AMENDMENTS TO THE DRAWINGS

Fig. 3

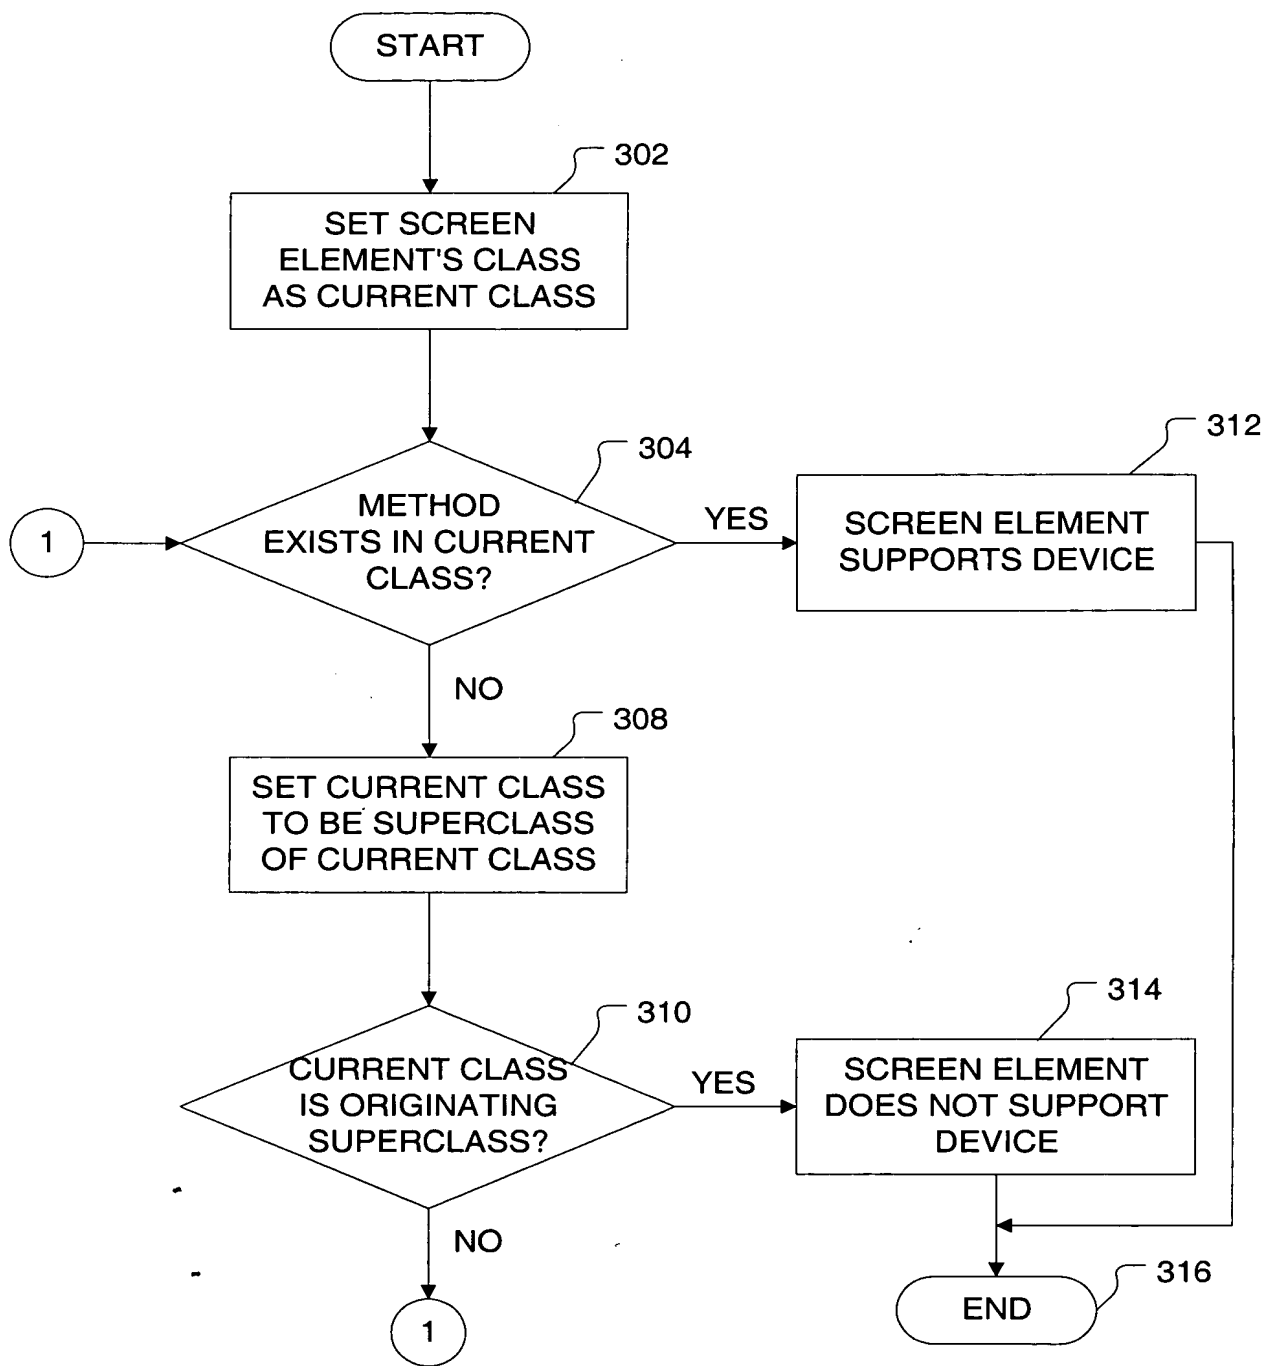
A replacement Figure 3 is provided with this Amendment. The replacement Figure 3 corrects the transition from operation 310 to operation 304 when the result of operation 310 is "NO." Support for this correction is found on page 21, lines 15-17, of the specification. Also, the "END" operation has been labeled "316" to be consistent with the description provided on page 21, line 9, of the specification.
